**Proposed text for Section 7.1
based on responses to Draft D1 Letter Ballot
processed at March 1995 Meeting**

Abstract: This paper presents the changes to section 7.1 in the Draft Standard P802.11/D1 as a result of the Response to Draft D1 Letter Ballot processed at the March 1995 Meeting as shown in the companion Document P802.11-95/71. Not all Letter Ballot comments were processed at the March 1995 Meeting.

Action: Adopt the changes in this paper to replace the relevant portions of Section 7.1 of P802.11/D1.

Figure 7-2 — Beacon transmission in an Ad Hoc network.

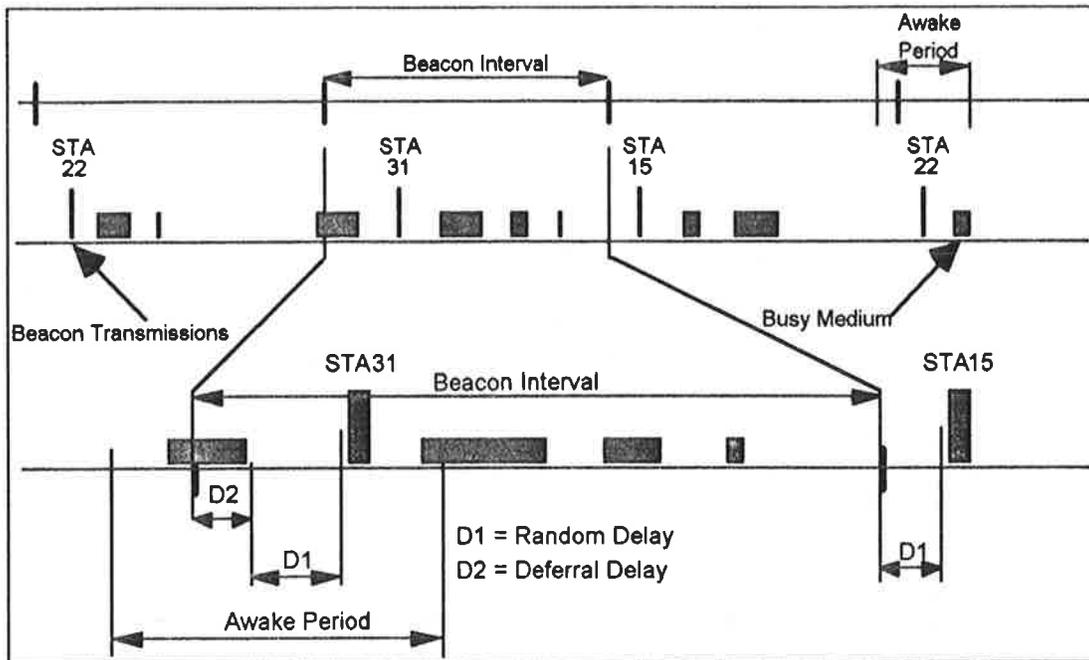
Beacon generation in an ad hoc network is distributed. All members of the BSS participate in Beacon generation. Each station shall maintain its own TSF timer which is used for $aMACMGT_Beacon_Interval$ timing. This defines a series of Target Beacon Transmission Times (TBTTs) exactly $aBeacon_Interval$ time units apart, time zero is defined to be a TBTT. At each TBTT ~~Each time the $MACMGT_Beacon_Interval$ time elapses, the station shall schedule a Beacon transmission to occur after a random delay. If a Beacon is received from another station during this delay period, the transmission is canceled. 1) save the timestamp from the most recently received Beacon, 2) calculate a random delay, 3) wait for the period of the random delay, 4) if no Beacon has arrived during the delay period, send one, go to step 1, otherwise 5) go to step 2. See Figure 7-2.~~

Figure 7-44-7 - Probe Response

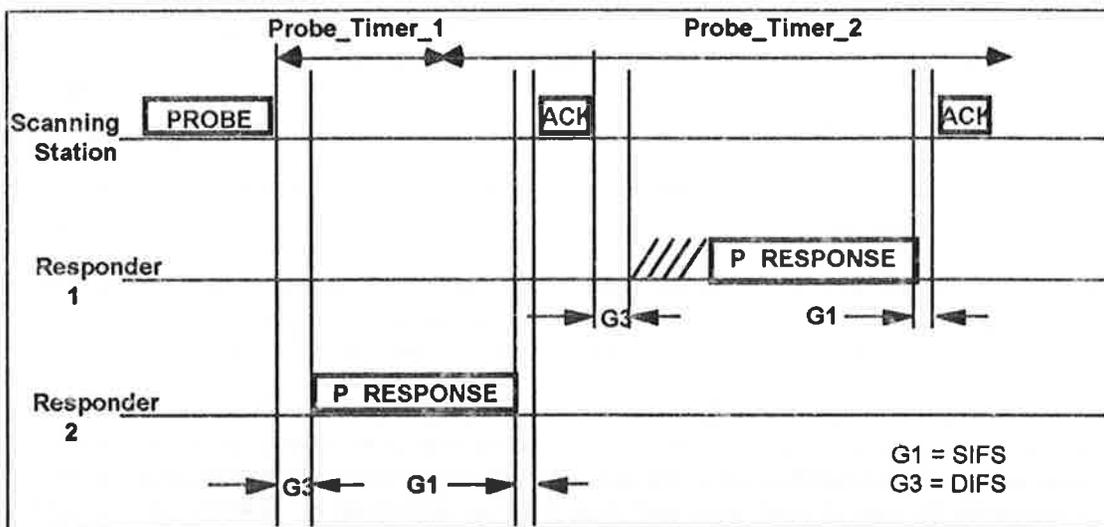
- a) wait until CCA indicates the medium is clear
- b) Send Probe with Broadcast Destination, ESSID, and broadcast BSSID
- c) Start Probe Timer 1
- d) If CCA indicates activity prior to expiration of Probe Timer 1 then start Probe Timer 2
Else If CCA indicates no activity before the expiration of Probe Timer 1 then Clear NAV, Scan next channel.
- e) When Probe Timer 2 expires, process all received Probe Responses.
- f) Clear NAV and Scan next channel. a) CSMA-defer
- b) Send Probe with Broadcast Destination, Specific ESSID, and Specific BSSID
- e) Start T1 timer
- d) If receive energy within T1 then start T2
Else If hear nothing within T1 then Clear NAV
Scan next channel.
- e) When T2 expires, process all received Probe Responses.
- f) Clear NAV and Scan next channel.
